VIRGINIA ELECTRIC AND POWER COMPANY
RICHMOND, VIRGINIA 23261

January 4, 2001

VIRGINIA ELECTRIC AND POWER COMPANY
NORTH ANNA POWER STATION UNITS 1 AND 2
RESPONSE TO REQUEST FOR ADDITIONAL INFORMATION
PROPOSED TECHNICAL SPECIFICATIONS CHANGES
REACTOR COOLANT SYSTEM PRESSURE/TEMPERATURE LIMITS
LTOPS SETPOINTS, AND LTOPS ENABLE TEMPERATURES

| Attachment 2 | Mark-up of Units 1 and 2 Technical Specifications Changes |

Figure 3.4-2 — North Anna Unit 1
Reactor Coolant System Heatup Limitations

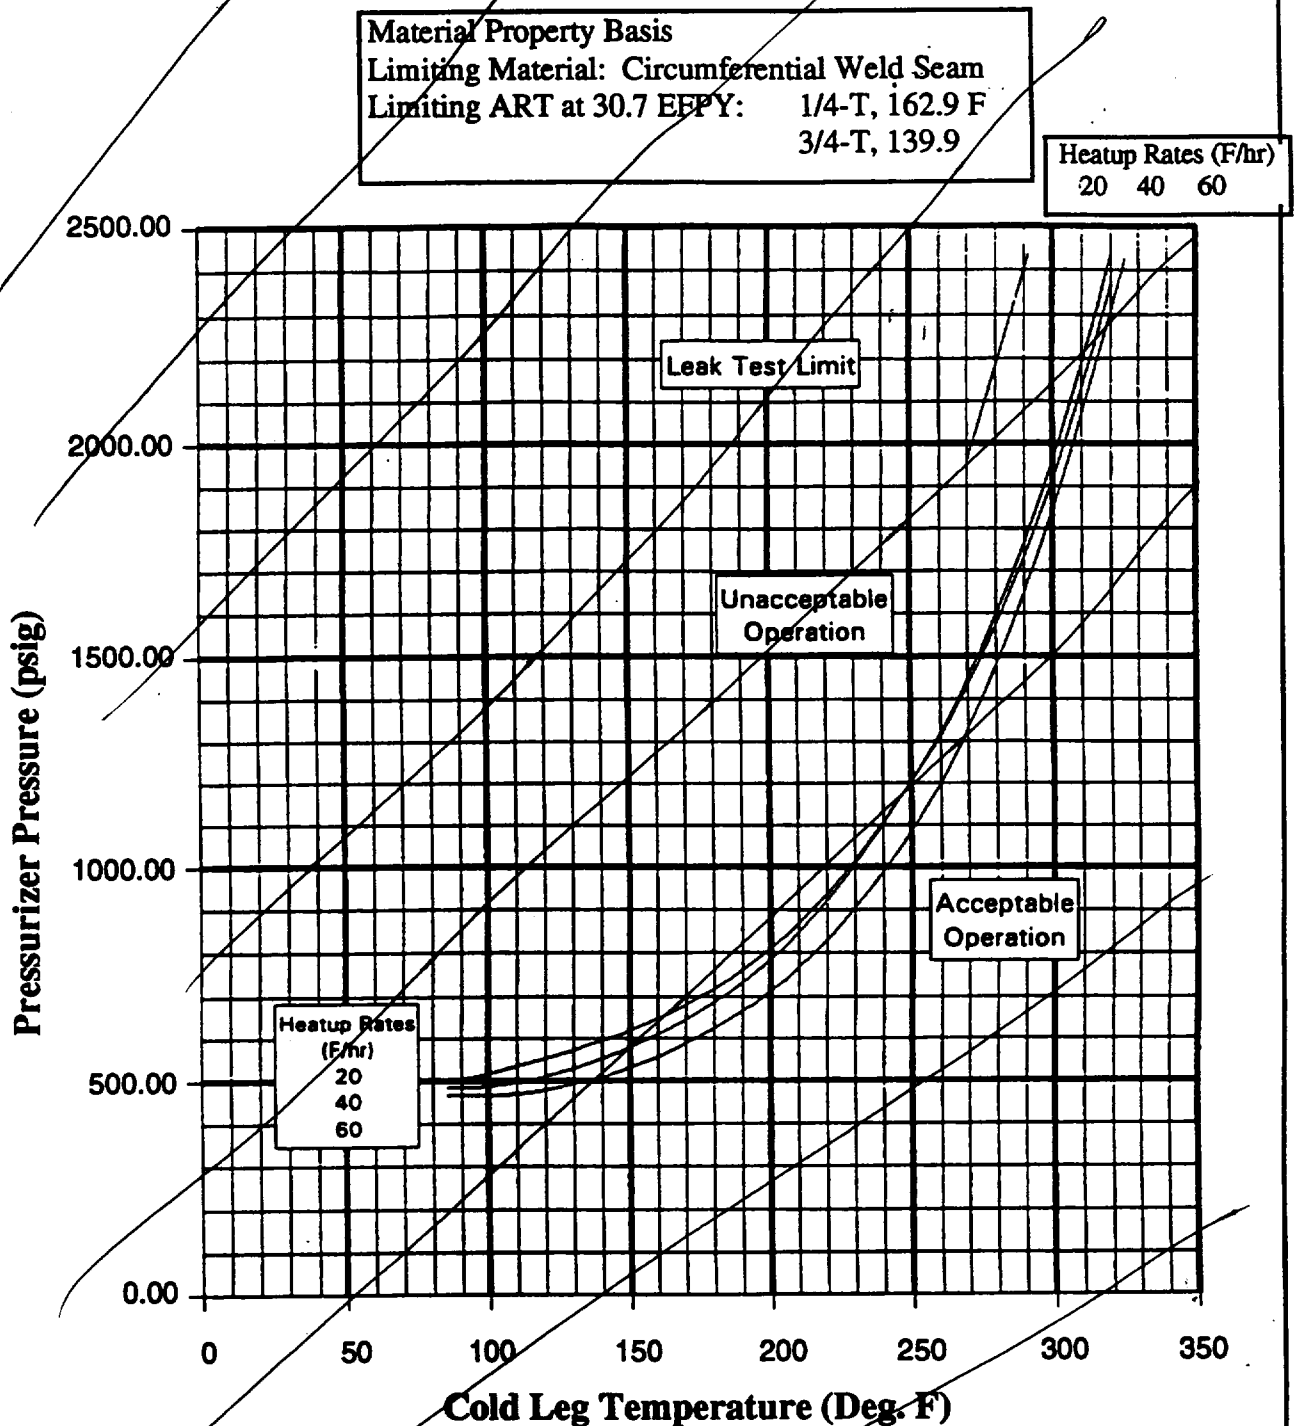
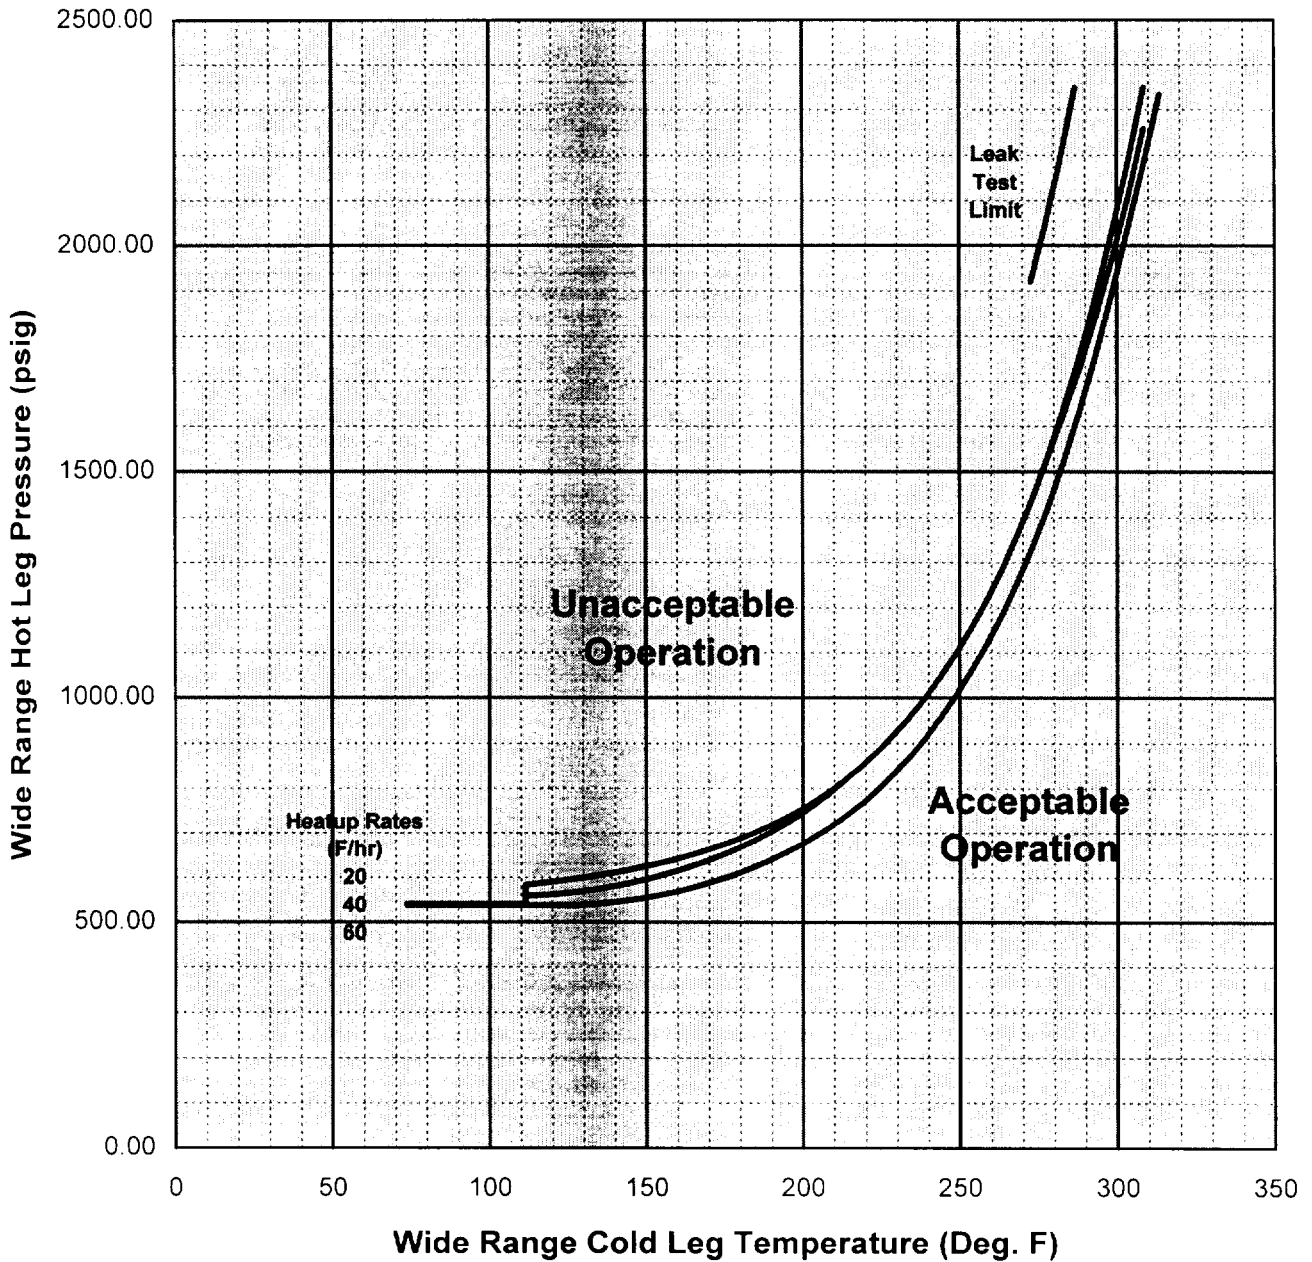
REPLACE WITH ATTACHED FIG 3.4-2

North Anna Unit 1 Reactor Coolant System Heatup Limitations (Heatup Rates up to 60 F/hr)
Applicable for the first 32.3 EFPY (Including Margins for Instrumentation Errors)

**Figure 3.4-3 — North Anna Unit 1
Reactor Coolant System Cooldown Limitations**

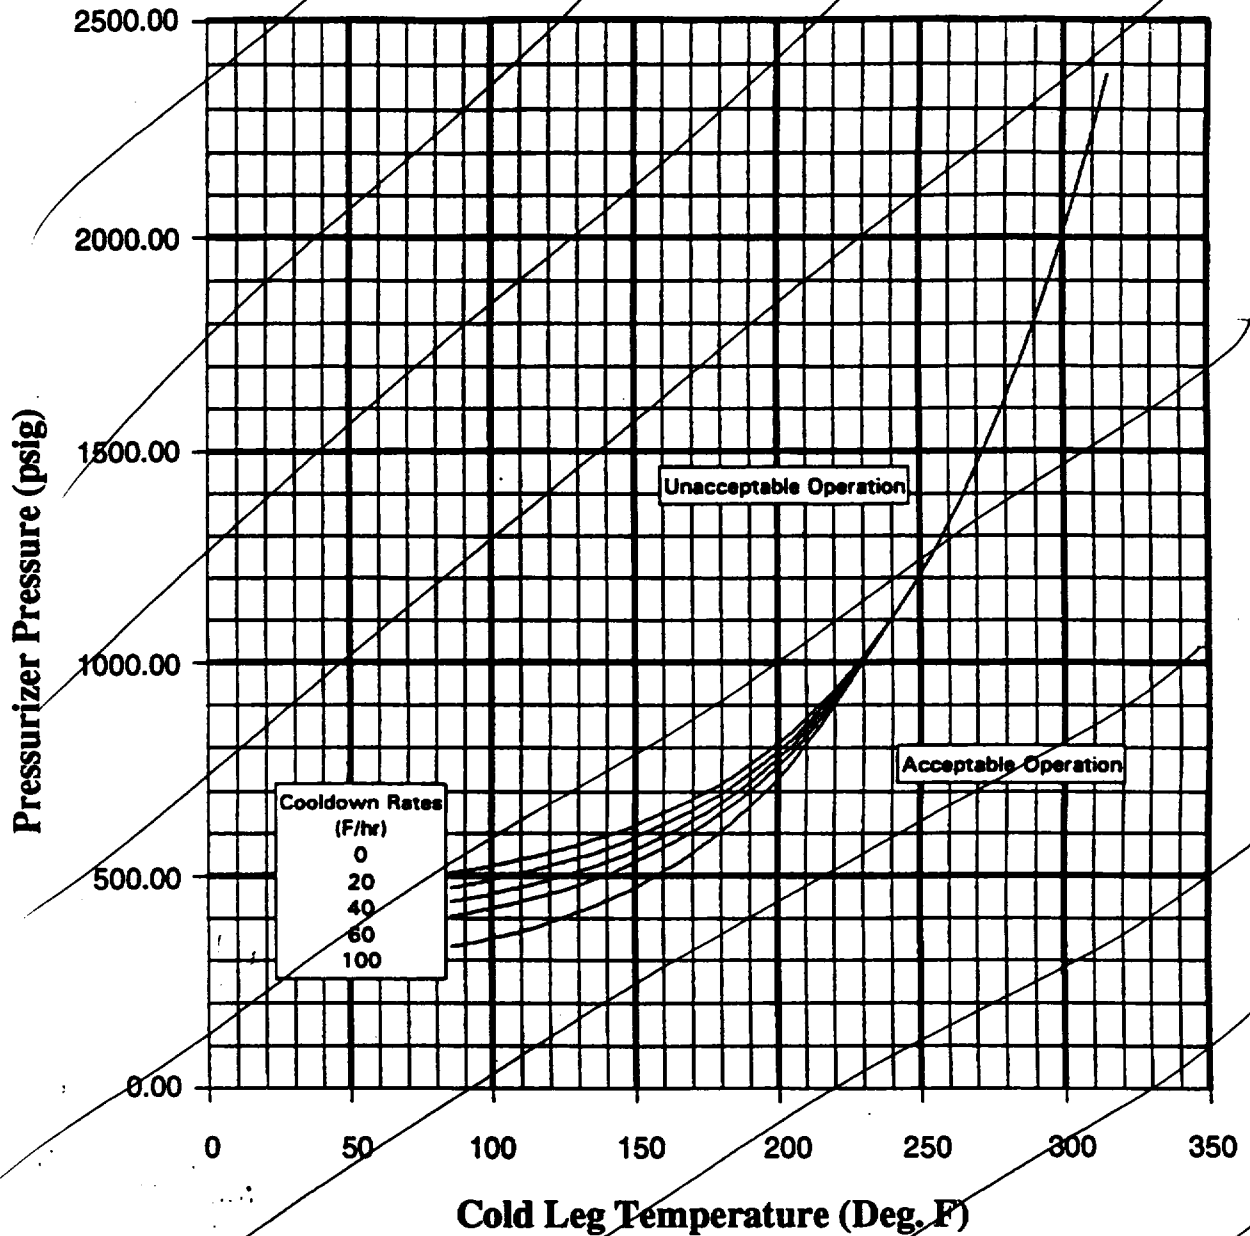
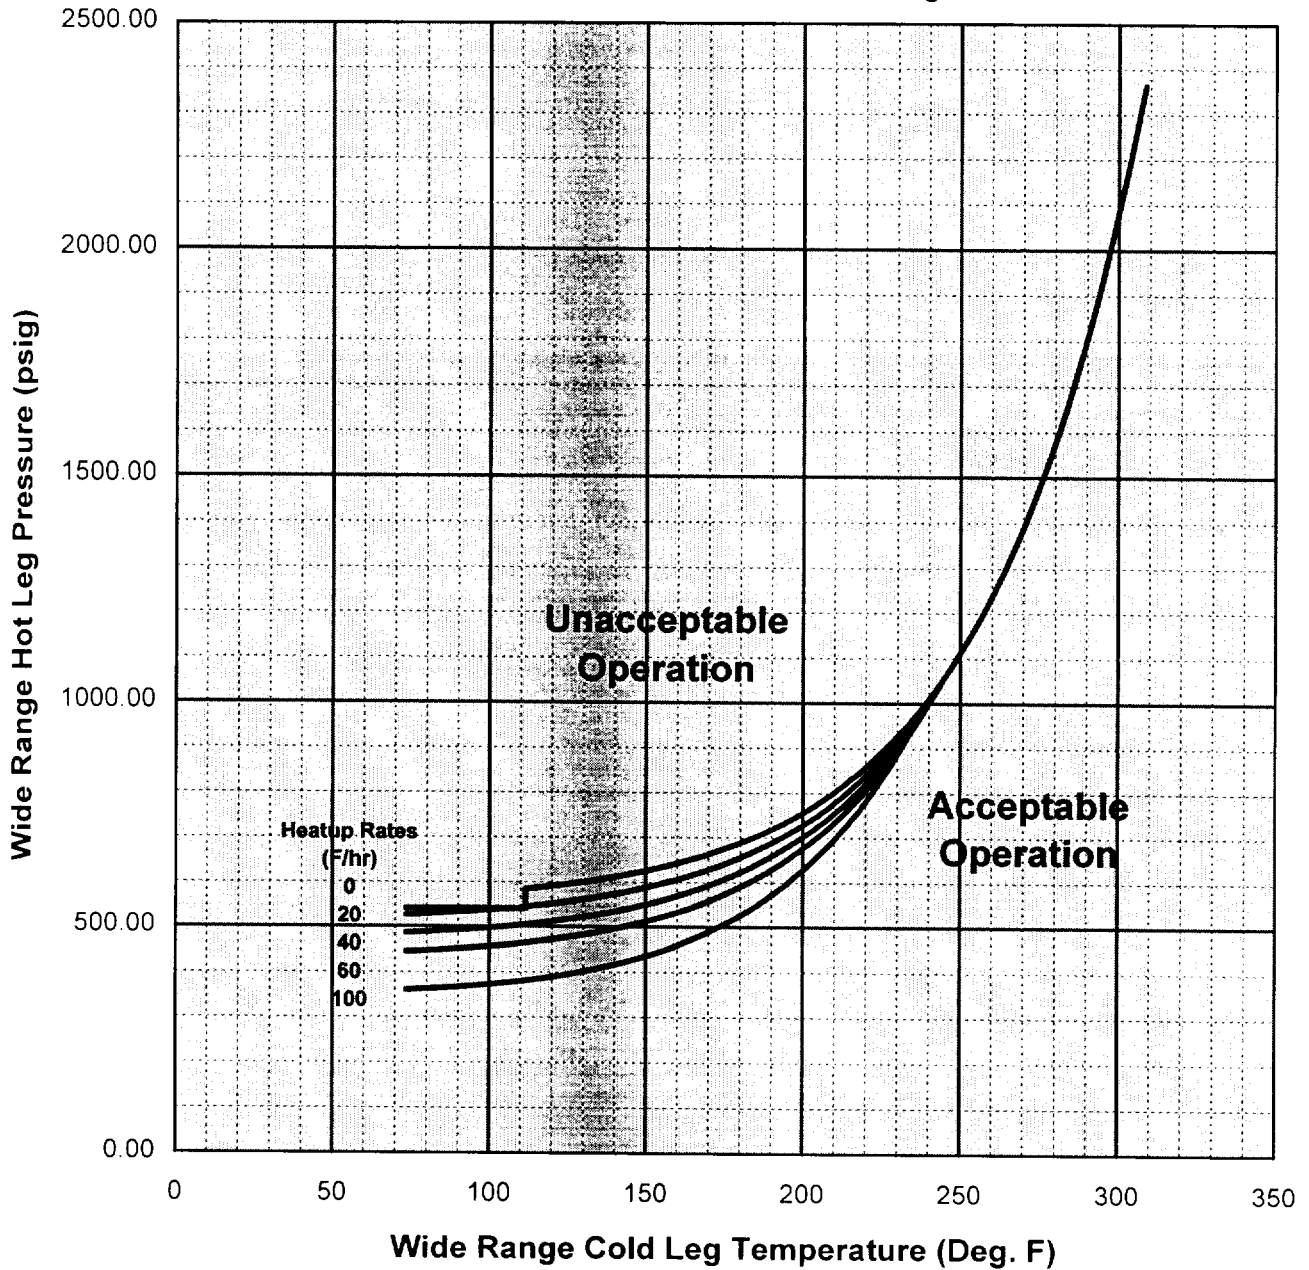
REPLACE WITH ATTACHED FIG 3.4-3

North Anna Unit 1 Reactor Coolant System Cooldown Limitations (Cooldown Rates up to 100 F/hr)
Applicable for the first 32.3 EFPY (Including Margins for Instrumentation Errors)

Figure 3.4-2 — North Anna Unit 2
Reactor Coolant System Heatup Limitations

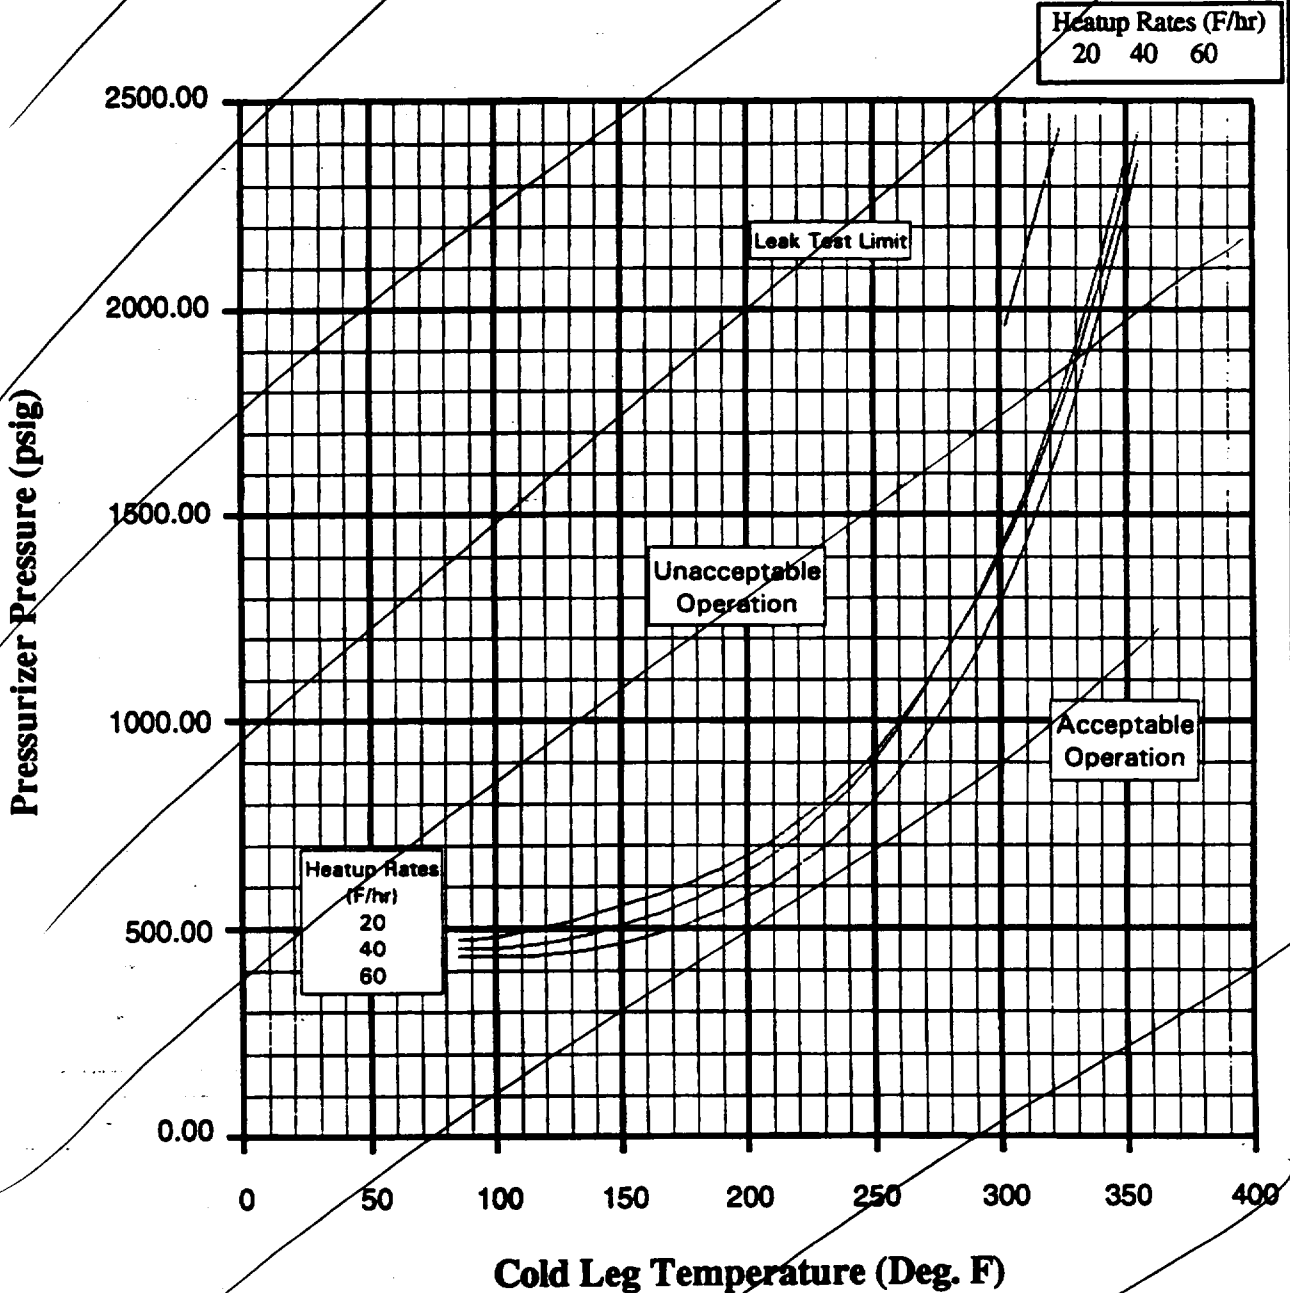
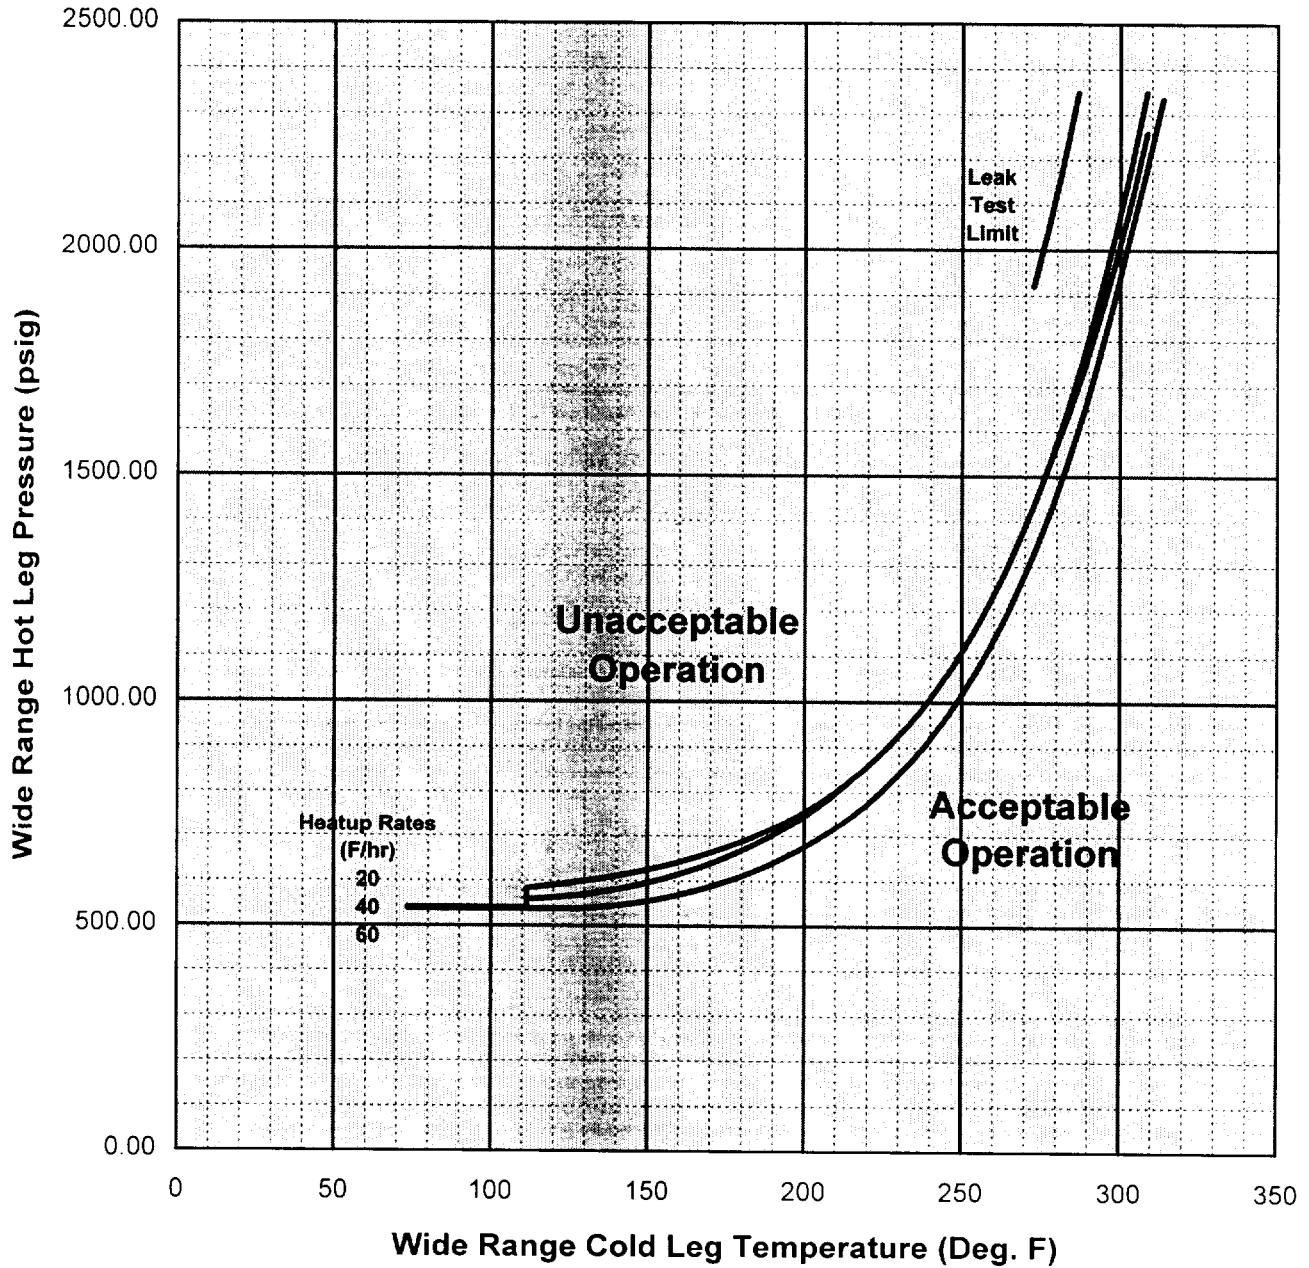
REPLACE WITH ATTACHED FIG 3.4-2

North Anna Unit 2 Reactor Coolant System Heatup Limitations (Heatup Rates up to 60 F/hr)
Applicable for the first 34.3 EFPY (Including Margins for Instrumentation Errors)
